Kansas Department of Agriculture
 Division of Water Resources
CHANGE: P/U WORKSHEET

RE: Water Right, File Nos. 19971 & 31853

DWR FIELD OFFICE APPLICATION FOR APPROVAL TO CHANGE THE PLACE OF USE AND/OR THE POINT OF DIVERSION

RE: Applications for Change in Place of Use
Water Right, File No. 19971 & 31853

**FILE NOS. 19971, 31853
APPLICATION TO CHANGE THE PLACE OF USE**

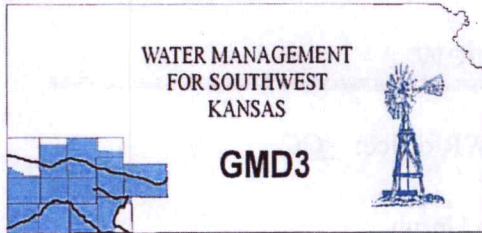
Is Proposed PU overlapping existing WRs? Keeping a complete overlap on the two water rights, but reducing acres back to the base acres after being in MOU and WCA.

Base Acres: [169 + 135 respectively] = 304 (+10).

This proposal is not reverting back to the reversionary acres like most MOUs, but is bringing in acres not originally authorized to match the current operation. With that in mind they are proposing 10 acres over combined base, which is allowable with the rules.

Recommendation: After review of all available information, it appears current area rules are met. They properly asked out of the WCA, which does not seem to raise any issues. Staff therefore recommends approval of the applicaiton.

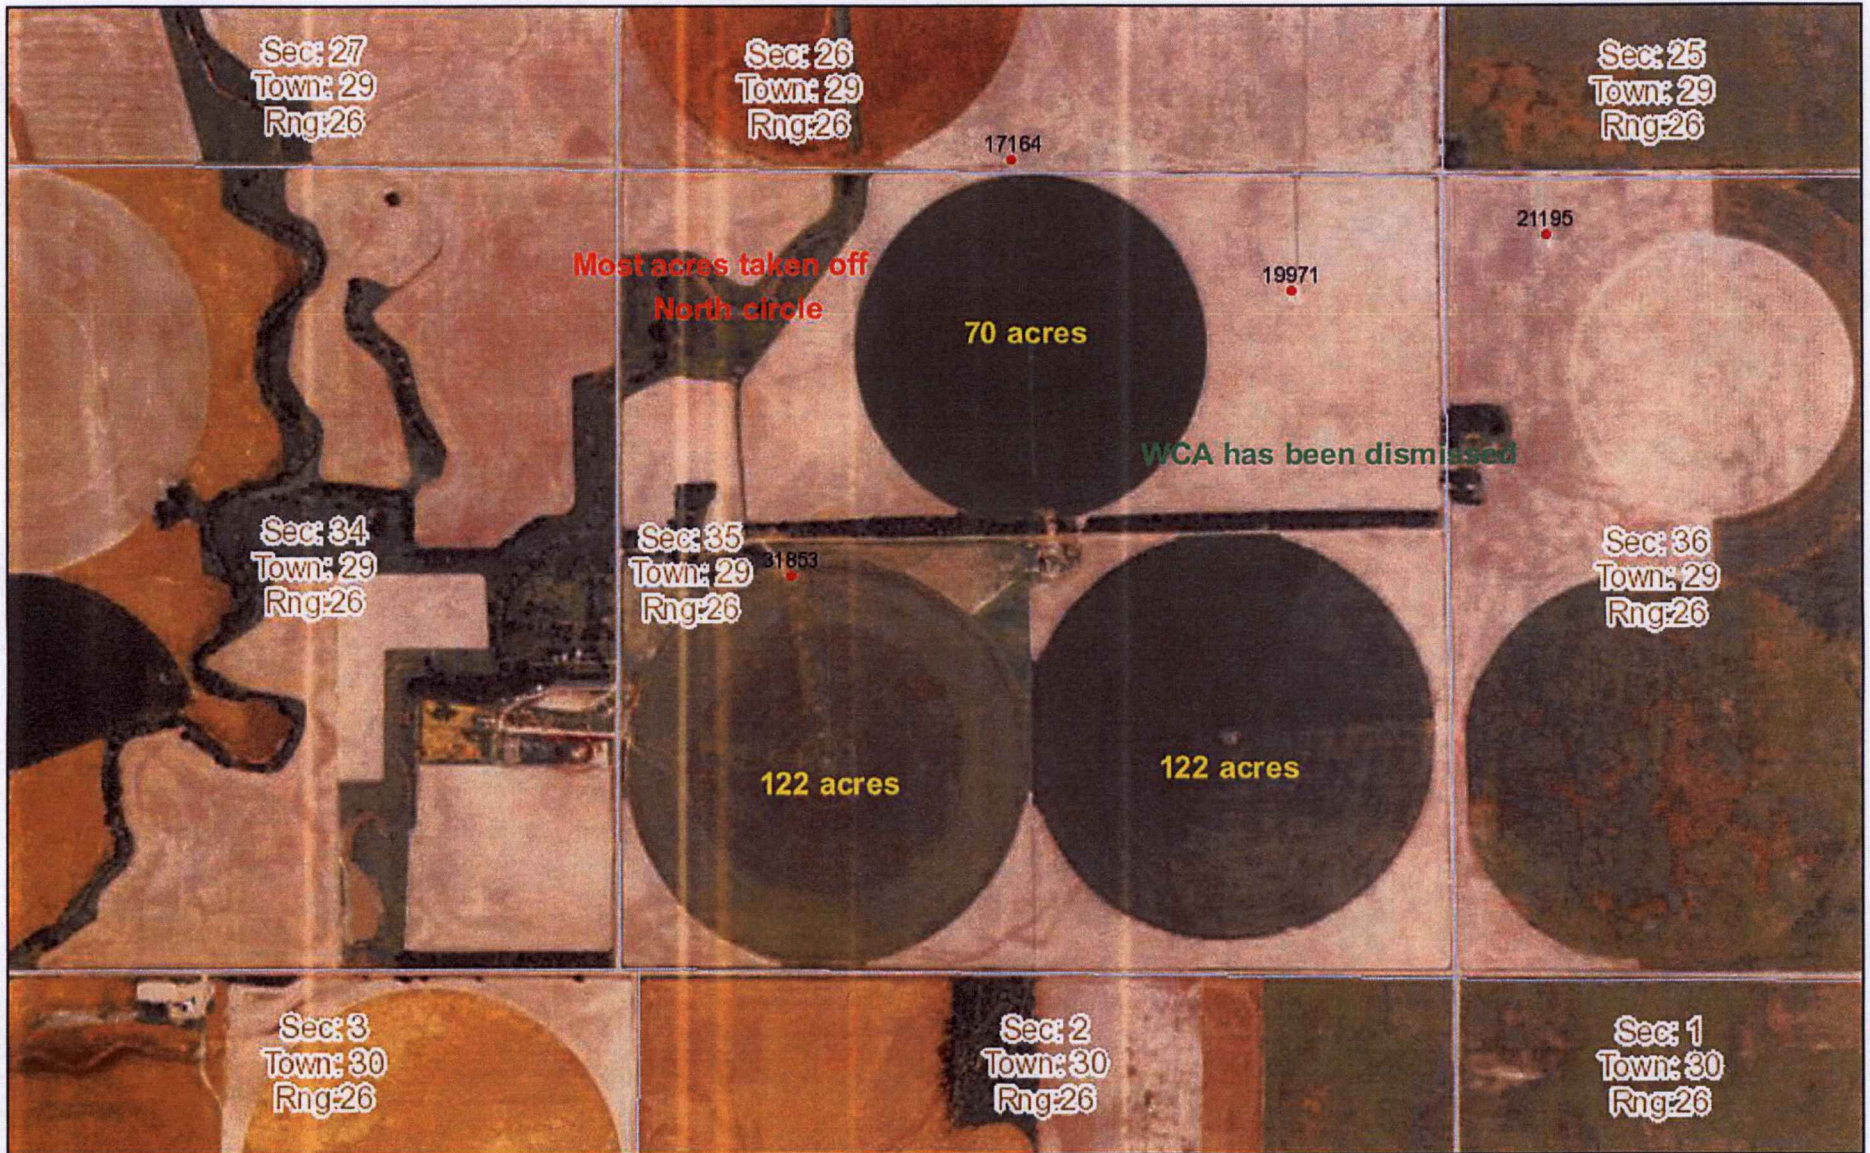
These WRs were in the MOU program prior to 2011, when apps were filed to get out of the program for the new land owner. New owner did not reduce the acres under pivot to meet the change applied for.

The water rights were then put into WCA program to continue watering the unauthorized acres, and then was subsequently sold.

Current owners opted out of the WCA and reduced the acres being watered.

Both WRs stayed within the WCA limits for the short time in the program and no issue with getting out of the volunteer program.
